**Validation report form for post-registration changes for
CDM project activities
(Version 02.0)**

Title and UNFCCC reference number of the project activity	Jilin Qianguo Chaganhu Wind Farm Project
Process track	<input type="checkbox"/> Prior approval <input checked="" type="checkbox"/> Issuance <input type="checkbox"/> Renewal of crediting period
Version number of the validation report on PRCs	01
Completion date of the validation report on PRCs	27/11/2018
Type(s) of PRCs	<input type="checkbox"/> Temporary deviations from the registered monitoring plan, monitoring methodology or standardized baseline <input checked="" type="checkbox"/> Corrections <input type="checkbox"/> Changes to the start date of the crediting period <input type="checkbox"/> Inclusion of a monitoring plan to a registered project activity <input checked="" type="checkbox"/> Permanent changes from registered monitoring plan, monitoring methodology or standardized baseline <input type="checkbox"/> Changes to the project design of a registered project activity <input type="checkbox"/> Types of changes specific to afforestation and reforestation project activities

Fig 1 Comparison of the monitoring system between the registered PDD and Revised PDD

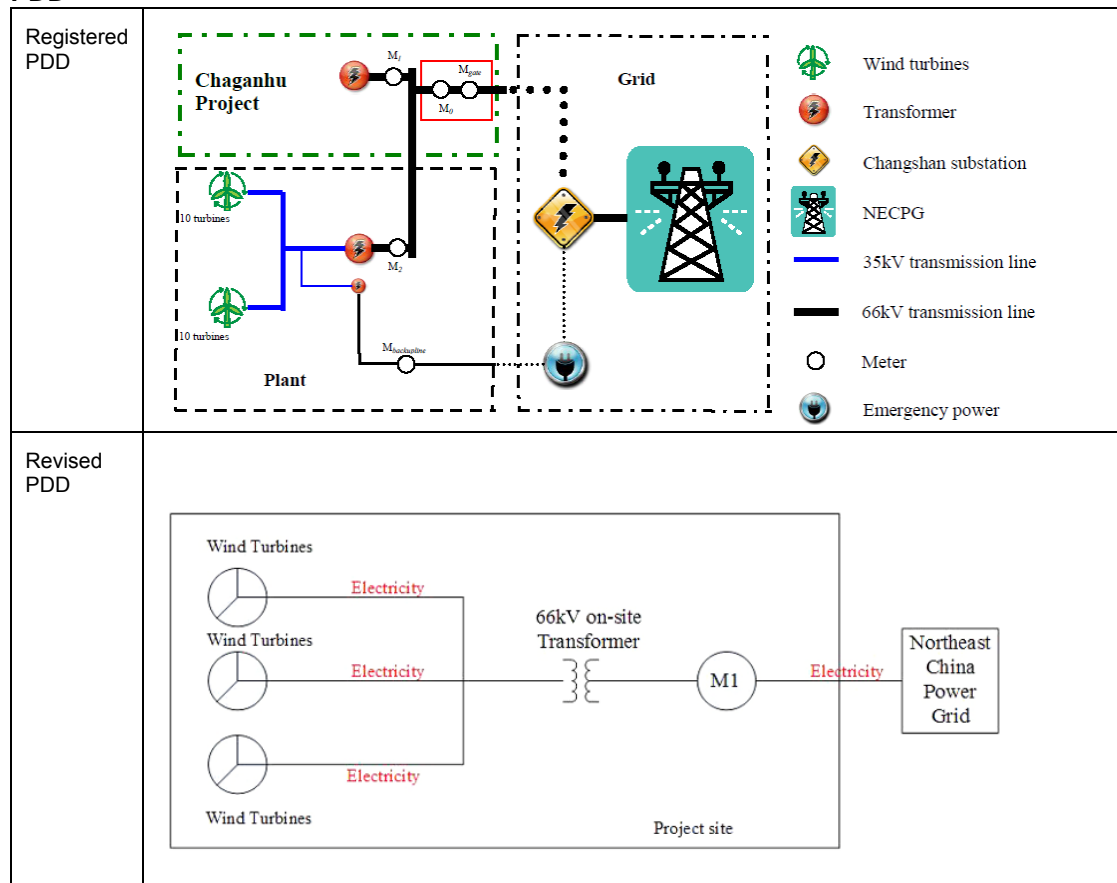
As per the registered monitoring plan, the electricity would be monitored by the main meter (M1) and the backup meter(M2) installed at low volt side of 66kV on-site Substation.

After the proposed project registered, it has been operated completely on 10/08/2013. As per the requirement of the Grid Company /4/, a meter (M1) has been installed at high volt side of 66kV on-site Substation to monitor the electricity supplied to NECPG by the proposed project ($EG_{export,y}$) and the electricity imported from NECPG by the proposed project ($EG_{import,y}$) (as shown in Fig 1 below).

Corresponding to the changes of the monitoring structure, the monitoring for the parameters $EG_{export,y}$ (electricity exported to the grid by the project) and $EG_{import,y}$ (electricity imported from the grid to the project) changed from directly measured by the meter M1 installed at the high volt side of 66kV on-site Substation to be calculated based on the measured values of the meters as below:

Findings	<p>CAR 2: "In the registered PDD, it stated that "In the registered PDD, two bi-directional meters (M_{gate}, M_0) will be installed to monitor $EG_{\text{export},y}$ and $EG_{\text{import},y}$. M_0 works as backup meter for M_{gate} when there is failures in M_{gate}, M_0 will be used. After another wind farm plant – Qingshantou project is connected to the same on- site substation, the M_{gate} and M_0 will be used to monitor electricity imported and exported from both two projects. Then, M_1 which monitors electricity from the proposed project will be implemented with M_2 which monitors electricity from Qingshantou project to calculate the exported and imported electricity from the proposed project as $M_{\text{gate}} * M_1 / (M_1 + M_2)$. In order to monitor the electricity imported for black start, one meter ($M_{\text{backupline}}$) will be installed to monitor $EG_{\text{backupline}, y}$. The accuracy of all the meters must be 0.5 or higher which means the error resulting from such equipment shall not exceed $\pm 0.5\%$ of full-scale rating." However, by on-site visit, CTI found that a meter (M_1) has been installed at the high volt side of 66kV on-site Substation to monitor the total electricity supplied to the grid by the proposed project and the imports from the grid by the proposed project. (Refer to Appendix 4)</p>

CAR ID	02	Section no.	D.6	Date: 21/11/2018
Description of CAR				
“In the registered PDD, two bi-directional meters (M_{gate} , M_0) will be installed to monitor $EG_{export,y}$ and $EG_{import,y}$. M_0 works as backup meter for M_{gate} when there is failures in M_{gate} , M_0 will be used. After another wind farm plant – Qingshantou project is connected to the same on- site substation, the M_{gate} and M_0 will be used to monitor electricity imported and exported from both two projects. Then, M_1 which monitors electricity from the proposed project will be implemented with M_2 which monitors electricity from Qingshantou project to calculate the exported and imported electricity from the proposed project as $M_{gate} * M_1 / (M_1 + M_2)$. In order to monitor the electricity imported for black start, one meter ($M_{backuptline}$) will be installed to monitor $EG_{backuptline, y}$. The accuracy of all the meters must be 0.5 or higher which means the error resulting from such equipment shall not exceed $\pm 0.5\%$ of full-scale rating.” However, by on-site visit, CTI found that a meter (M_1) has been installed at the high volt side of 66kV on-site Substation to monitor the total electricity supplied to the grid by the proposed project and the imports from the grid by the proposed project.

<p>monitoring plan;</p> <ul style="list-style-type: none"> the monitoring means of $EG_{\text{export},y}$ and $EG_{\text{import},y}$ is reasonable. <p>The PDD has been revised to indicate the changes from the registered monitoring plan. Through the on-site investigation and the document review, the Verification Team has confirmed that the actual monitoring structure is in accordance with the Power Purchase Agreement /4/ and revised monitoring plan reflects the actual project information.</p> <p>As per the CDM project standard for project activities (Ver.1.0), a request for approval of a post-registration change may be suitable to be submitted under the issuance track:</p> <ol style="list-style-type: none"> Any corrections to project information¹ of a registered clean development mechanism (CDM) project activity that do not affect the design of the project activity; Temporary deviations from the registered monitoring plan for which alternative monitoring arrangements are proposed, if the proposed alternative monitoring arrangements produce a conservative estimate of greenhouse gas (GHG) emission reductions or net anthropogenic GHG removals; Changes to the monitoring of a registered CDM project activity that have no material impact on the applicability of the applied methodologies or the accuracy and completeness of the monitoring; Changes to the project design of a registered CDM project activity that do not adversely impact any of the following: <ol style="list-style-type: none"> The applicability and application of the applied methodologies and, where applicable, the applied standardized baselines with which the project activity has been registered; The additionality of the project activity; The scale of the project activity. Changes to the project design to use the positive list for demonstrating additionality in the latest valid version of the "Methodological tool: Demonstration of additionality of small-scale project activities" or the "Methodological tool: Demonstrating additionality of microscale project activities"; The types of changes listed in the "Guidelines on accounting of specified types of changes in A/R CDM project activities from the description in registered project design document". <p>As stated above, the changes of the proposed project are only related to the changes on the quantity and location of the monitoring equipment (i.e. the meters need to be installed at the 35kV transmission lines of each project for cutting the quantity of total electricity of two projects as per the requirement of PPA). It considers the changes belongs to the item (c), thus the proposed changes do not require the prior approval by the EB. CTI confirms that the changes do not affect the application of the applied methodology and do not reduce the level of accuracy and completeness of the monitoring compared with the requirements contained in the registered monitoring plan. And also the changes do not lead to a reduction in the accuracy of the calculation of emission reductions.</p>

Project participant response				Date: 22/11/2018
There are permanent changes to the registered monitoring plan, Changes that are being submitted with this monitoring report as part of the request for issuance (post-registration change - issuance track) as applicable from this monitoring period.				
Documentation provided by project participant				
Diagram of power connection system				
DOE assessment				Date: 23/11/2018

The Revised PDD has been provided by PP to indicate the permanent changes in the monitoring system. The Verification Team confirms the updated monitoring system is consistent with the actual condition and according to the requirement of the Grid Company. As per the Ver.1.0 of CDM project standard for project activities, these changes do not need to get the prior approval from EB. Therefore, the Revised PDD will be submitted following the verification documents.
CAR 2 is closed.
